Illinois Department of Transportation
2300 South Dirksen Parkway / Springfield, Illinois / 62764

Subject: Revision #215

Date: August 20, 2013

Revision #215 of the Highway Standards, effective January 1, 2014, is now available on the Department's website.
The revisions are as follows:

STANDARD 420111–03

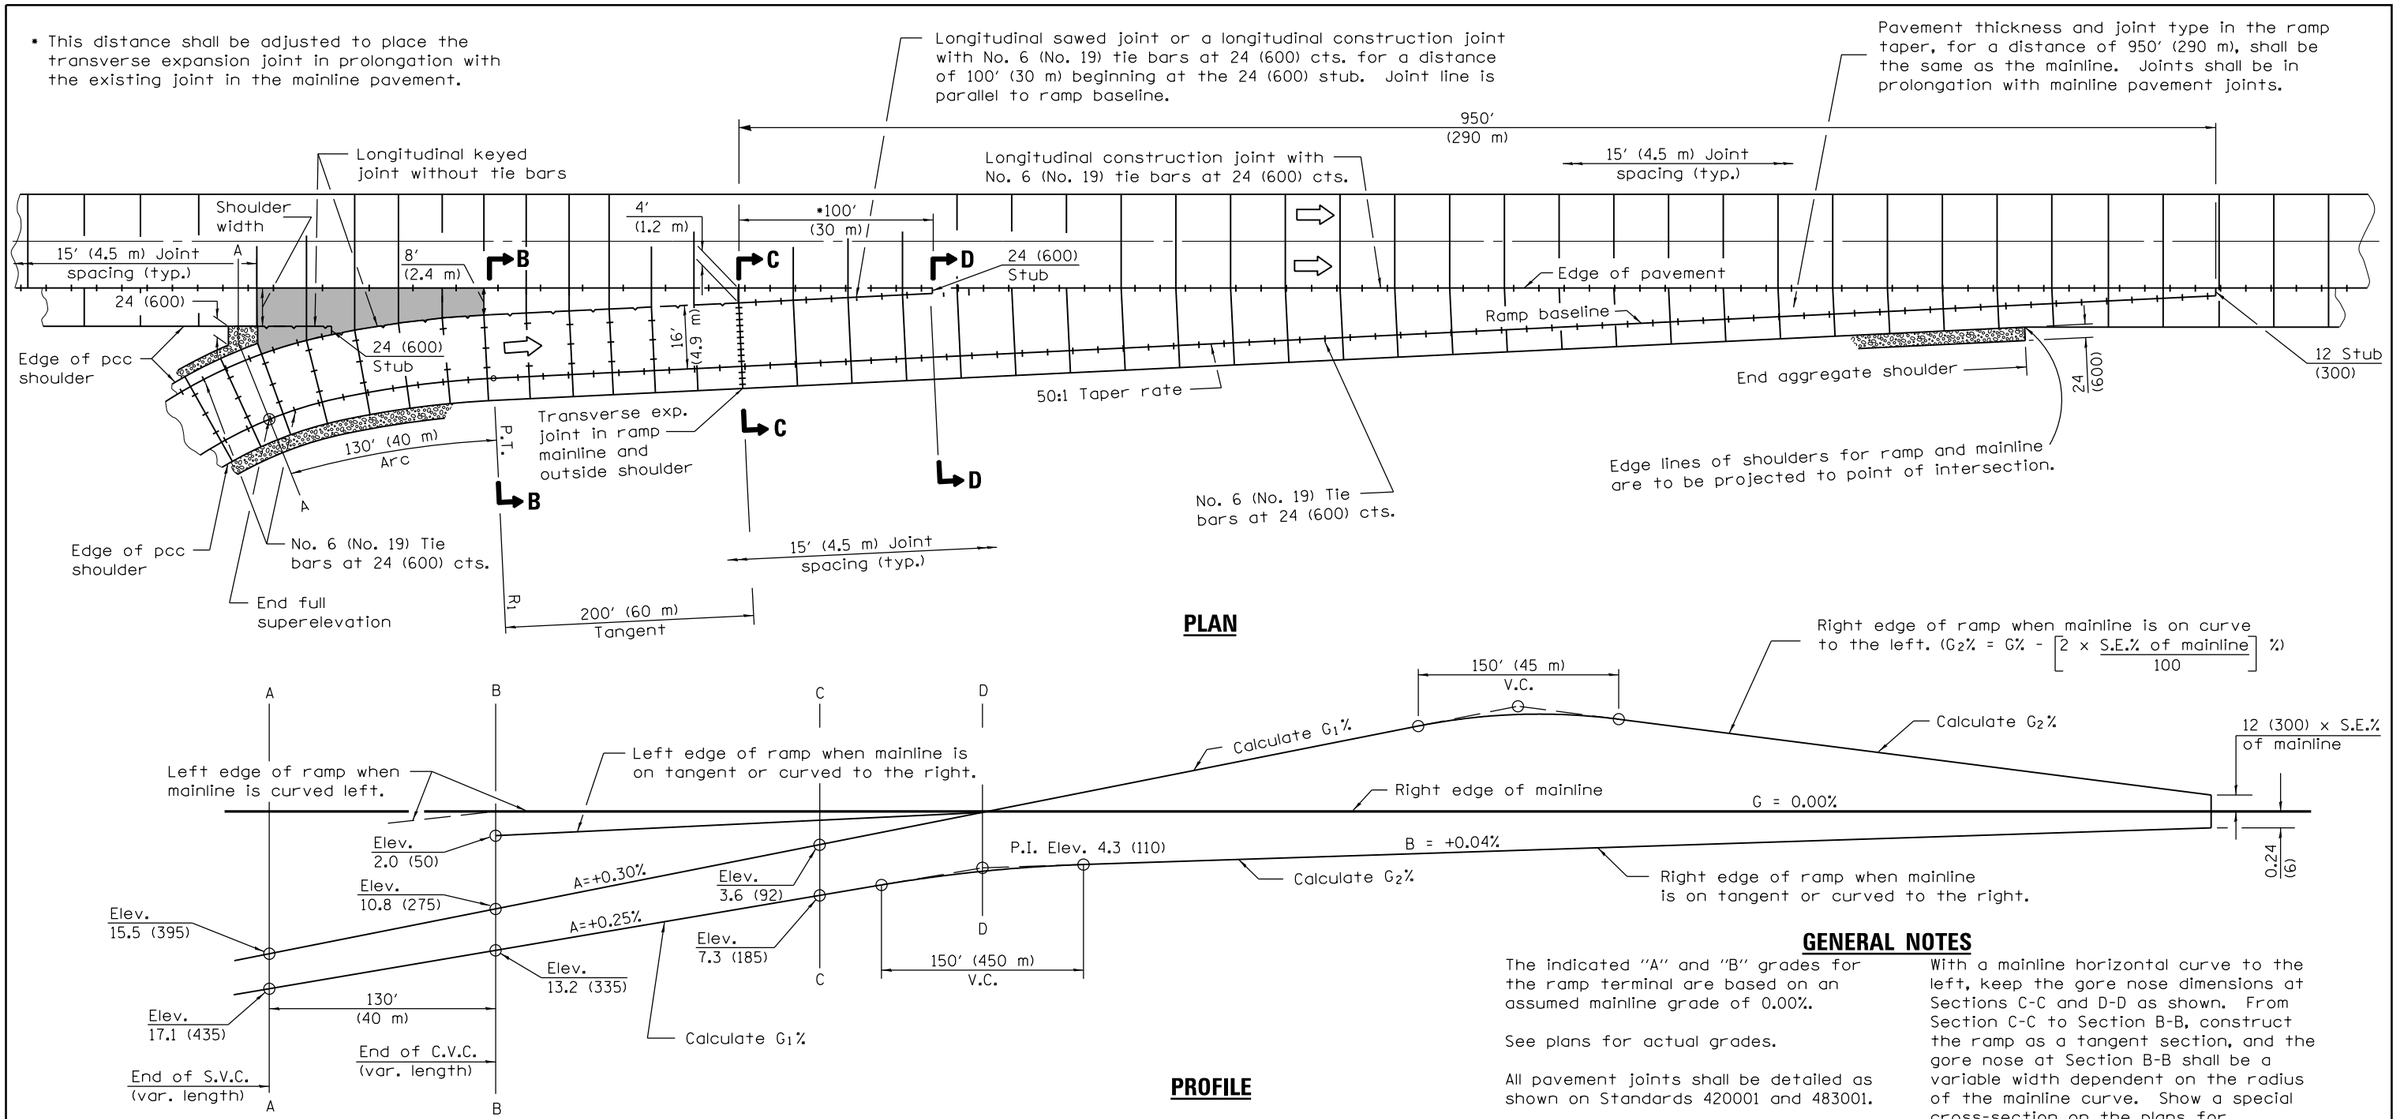
DATE	REVISIONS
1-1-14	Now show transverse joint
	at sec. C-C extended
	through shoulder.
1-1-08	Switched units to
	English (metric).
	Revised Gen. Notes.

STANDARD 421101–09

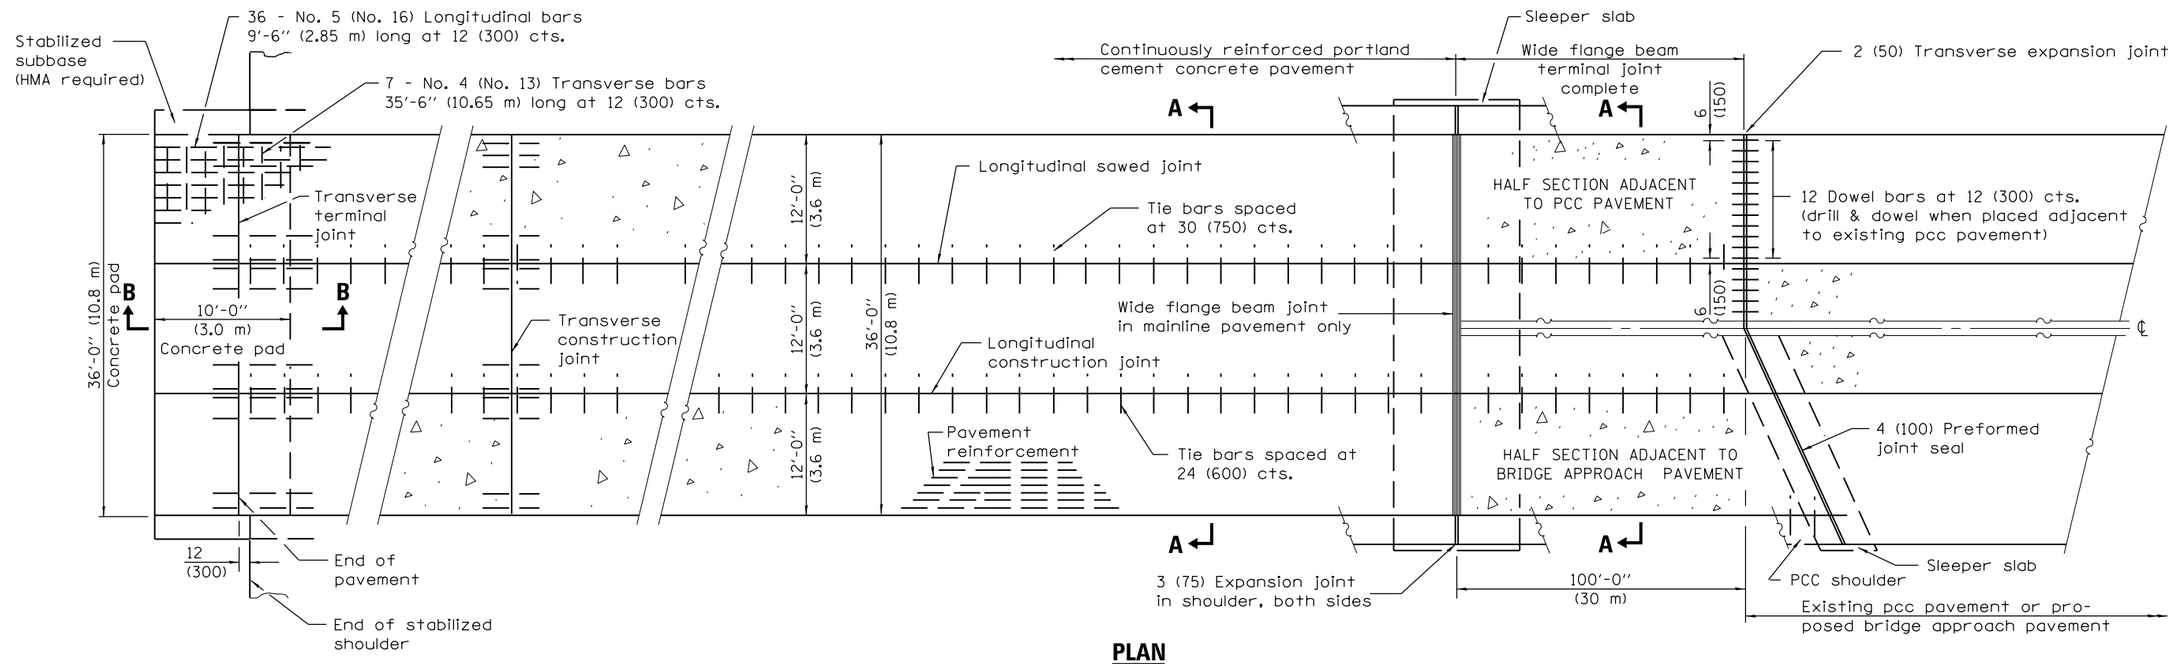
DATE	REVISIONS
1-1-14	Added exp. jnts. in shlds. &
	omitted bars, cnst. jnt. over
	wide flange beam slpr slab.
1-1-11	Corrected weld symbol on
	OPTIONAL ADJUSTABLE CHAIR
	detail.

STANDARD 421106–09

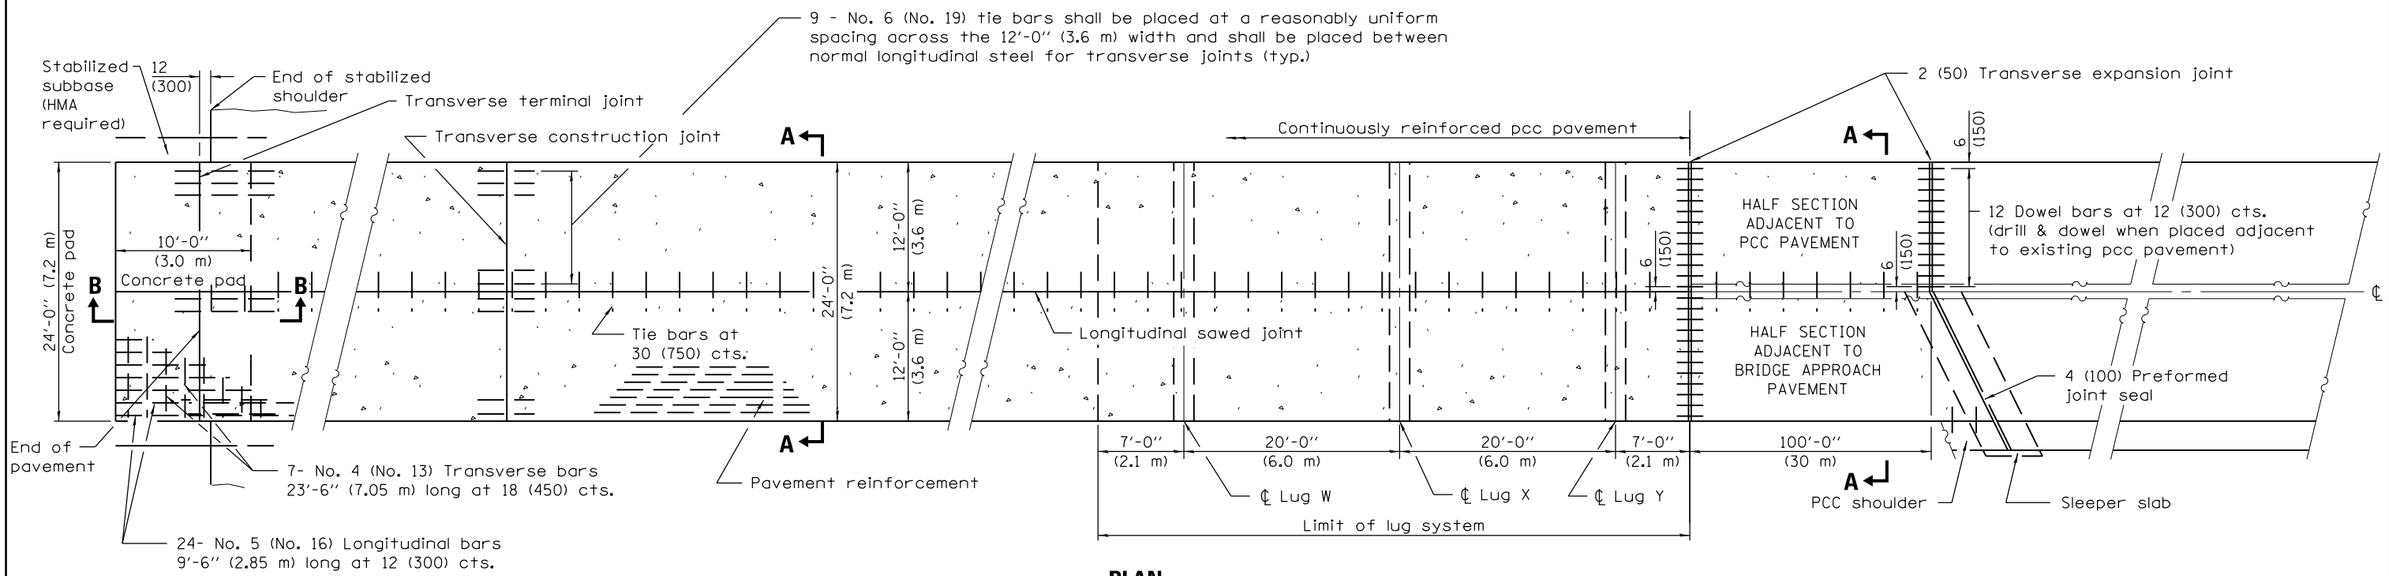
Removed	Inserted	Remarks
421106-08	421106-09	Added expansion joints in shoulders and omitted bars and optional construction joint over wide flange beam sleeper slab.
424021-01	424021-02	Revised sidewalk width. Revised General Notes to limit curb radii to 6' (1.83 m) minimum.
Division 500 Index January 1, 2013	Division 500 Index January 1, 2014	Updated.
542001-03	542001-04	Corrected 'L' for 1:3 slope and 60 (1500) pipe inside diameter in table on Sheet 1. Corrected some metric values to agree with AASHTO pipe diameters.
542006	542006-01	Corrected 'L' for 1:3 slope and 60 (1500) pipe inside diameter in table on Sheet 1. Corrected some metric values to agree with AASHTO pipe diameters.
542206-02	542206-03	Corrected skew angles in table on Sheet 5.
542311-04	542311-05	Added 27 (675) pipe to PIPE GRATE SCHEDULE FOR PIPE CULVERT END SECTIONS table. Modified dimension in SECTION D-D.
Division 600 Index January 1, 2013	Division 600 Index January 1, 2014	Updated.

DATE	REVISIONS
1-1-14	Added exp. jnts. in shlds. &
	omitted bars, cnst. jnt. over
	wide flange beam slpr. slab.
1-1-11	Corrected weld symbol on
	OPTIONAL ADJUSTABLE CHAIR
	detail.

STANDARD 631031–12

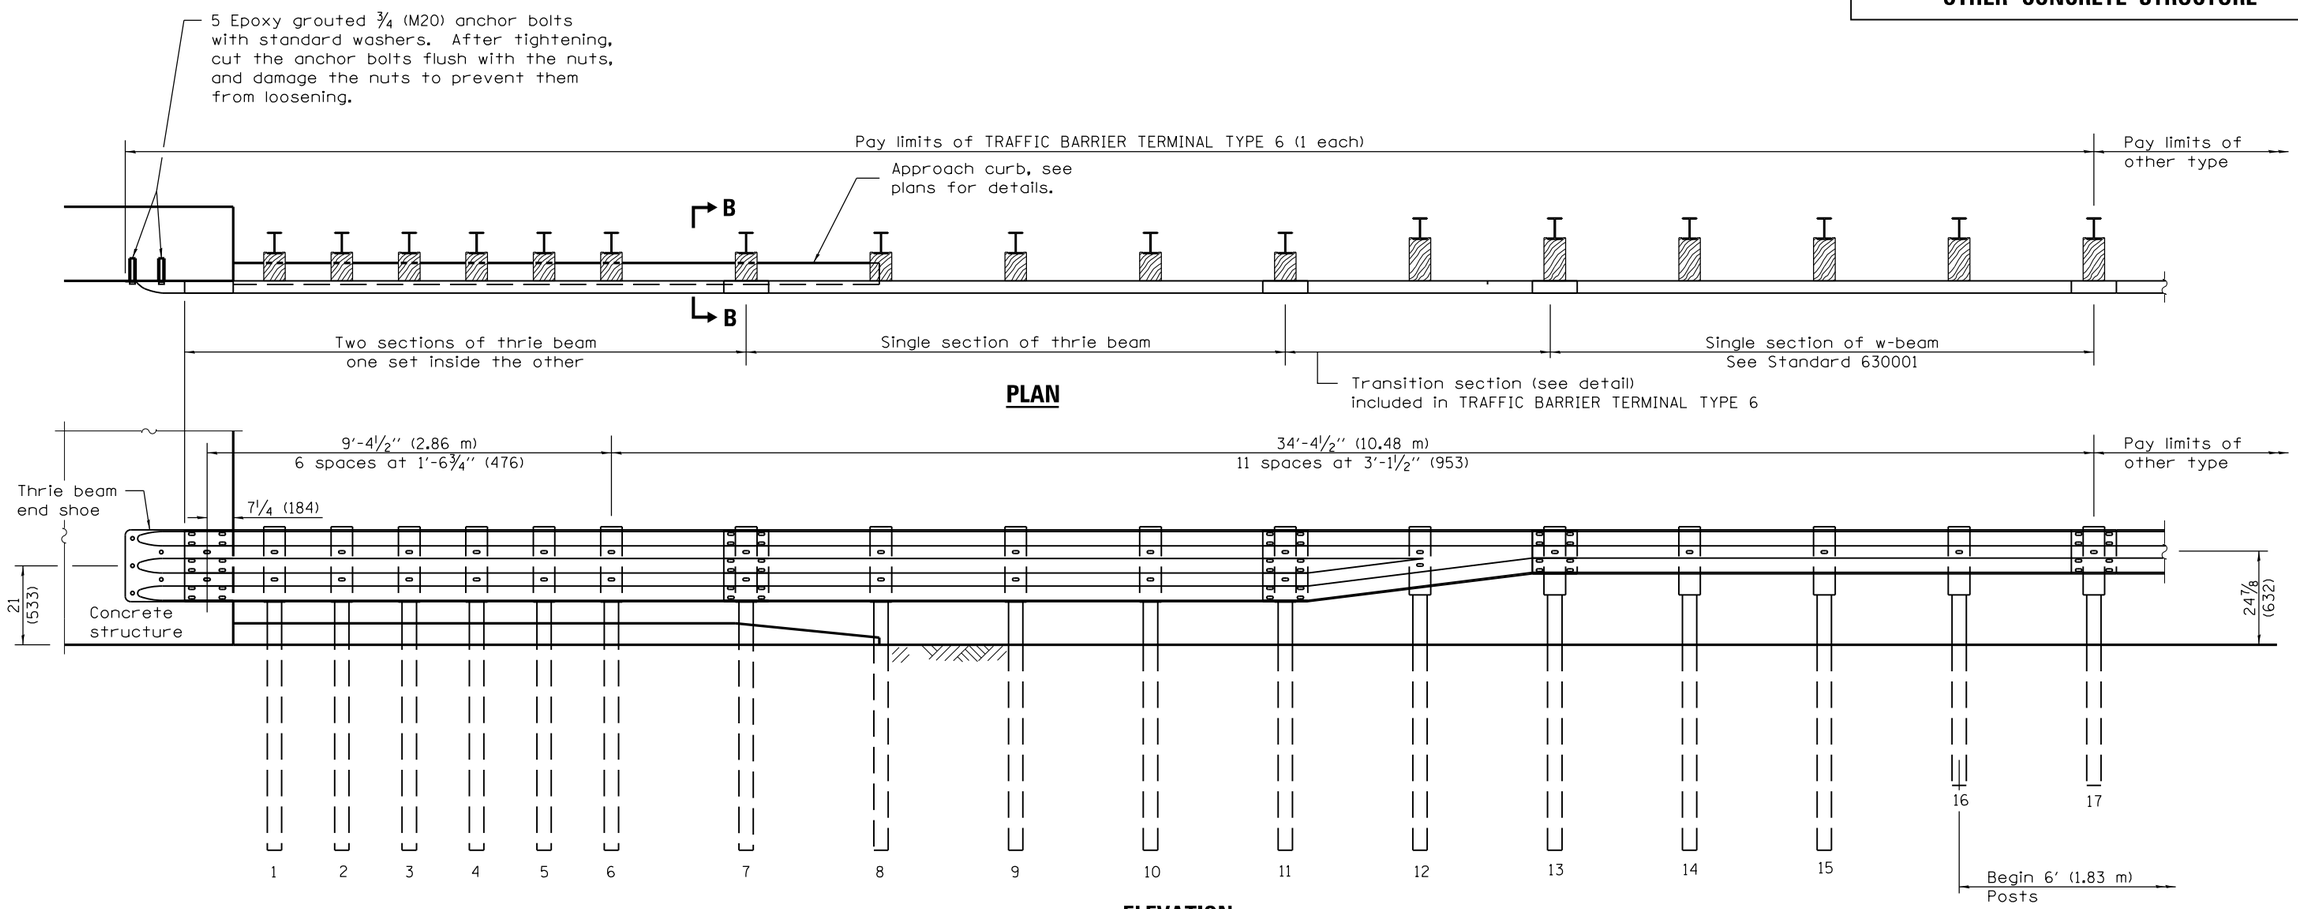
Removed	Inserted	Remarks
602601-02	602601-03	Omitted detail for lifting hole or lifting loop.
631031-11	631031-12	Revised height of thrie beam. Omitted longitudinal taper on parapet.
631033-04	631033-05	Added section A-A symbol to plan view. Revised height of thrie beam.
638001-02		Deleted standard.
643001-01	643001-02	Revised distance from barrels to hazard.
Division 700 Index January 1, 2012	Division 700 Index January 1, 2013	Updated.
701006-04	701006-05	Revised worker sign number to agree with current MUTCD.
701011-03	701011-04	Revised worker sign number to agree with current MUTCD.
701101-03	701101-04	Revised worker sign number to agree with current MUTCD.
701316-07	701316-08	Added vertical panels at lane shifts. Added vertical panel detail.
701400-06	701400-07	Revised photo enforced sign number. Added advanced warning speed reduction sign for freeway/expressways having 70 mph posted speed limit.

STANDARD 701421–06

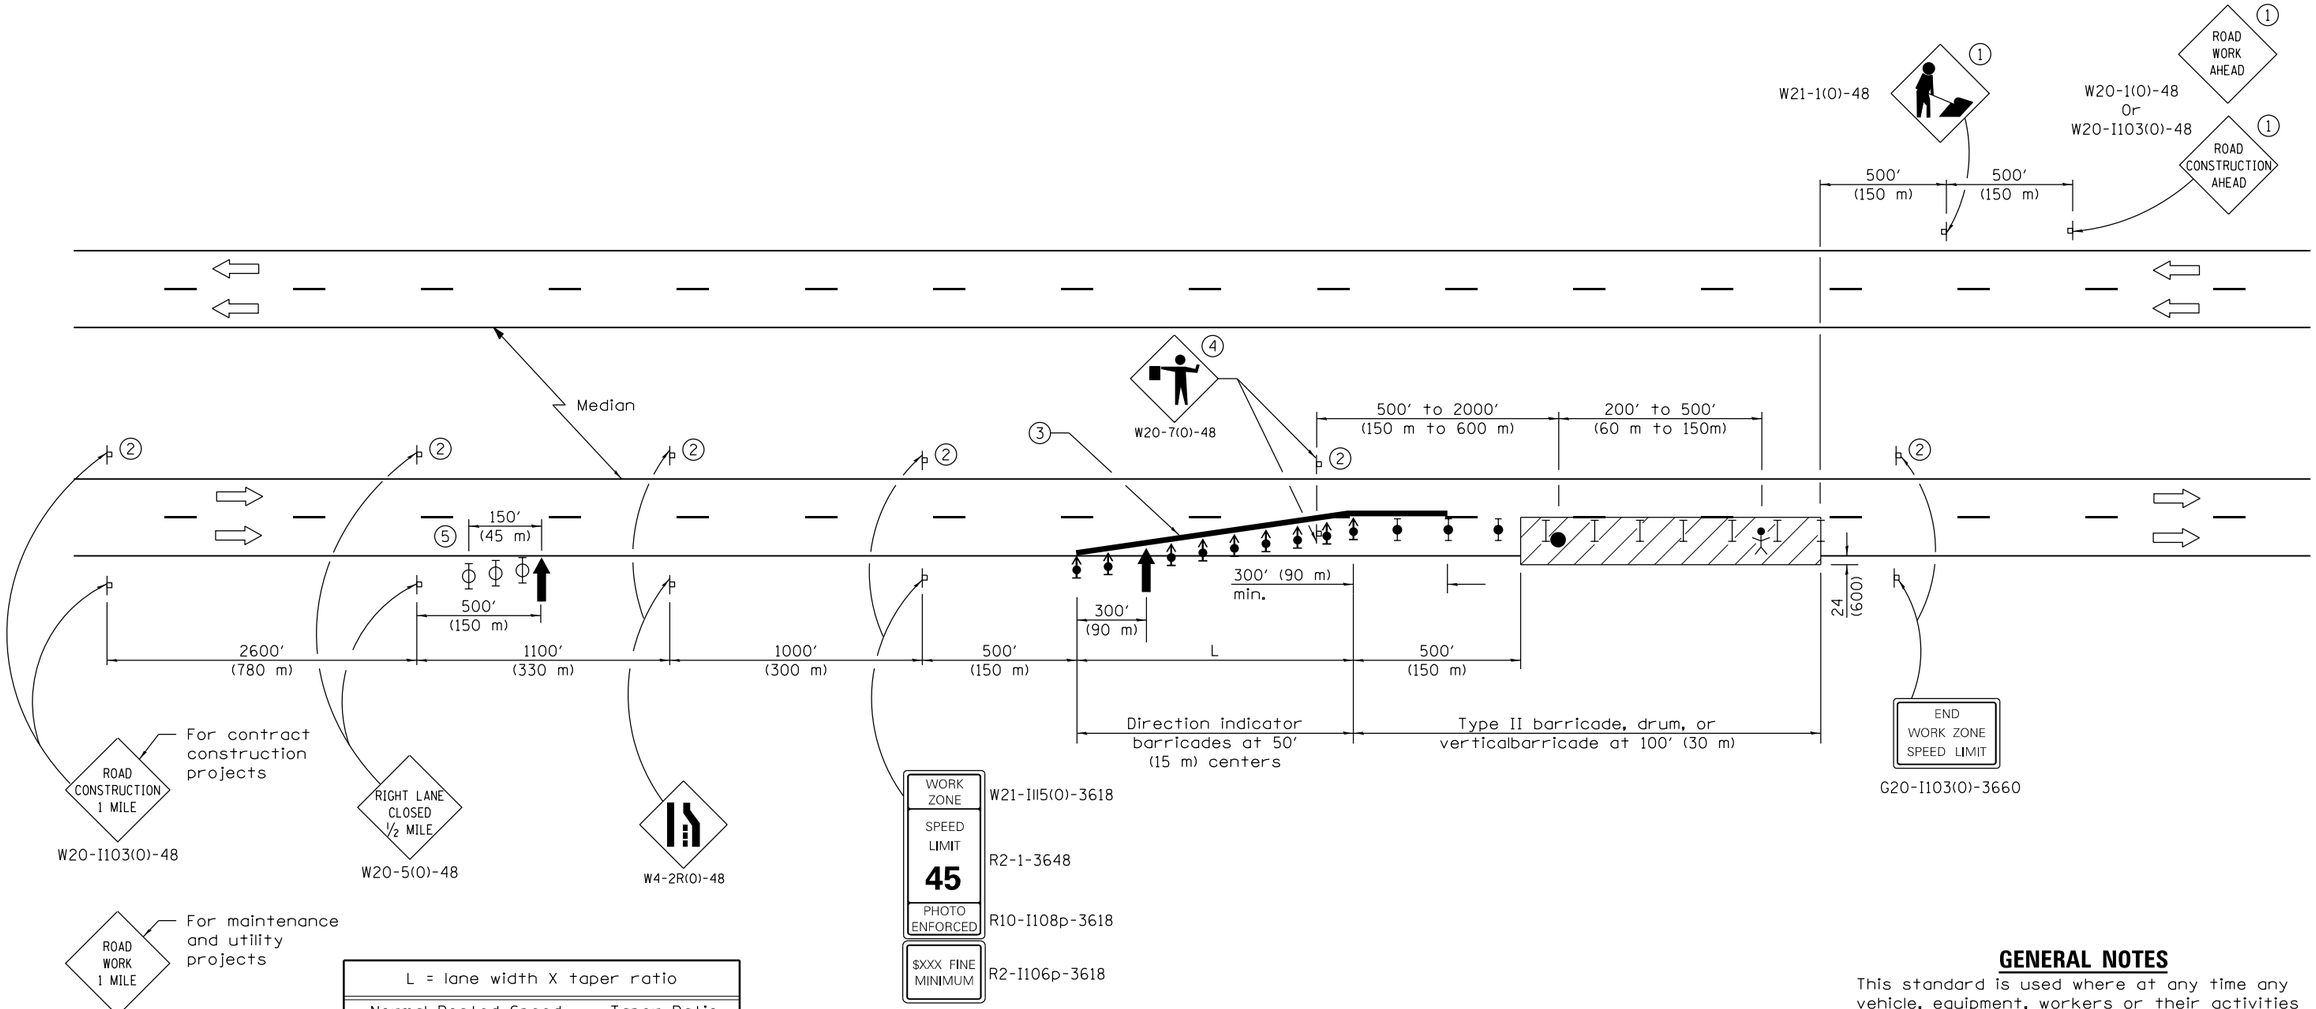
701401-07	701401-08	Revised photo enforced sign number. Relocated sign at end of work area.
701406-07	701406-08	Revised photo enforced sign number. Relocated sign at end of work area.
701421-05	701421-06	Revised worker sign number to agree with current MUTCD. Revised photo enforced sign number.
701422-05	701422-06	Revised worker sign number to agree with current MUTCD. Revised photo enforced sign number.
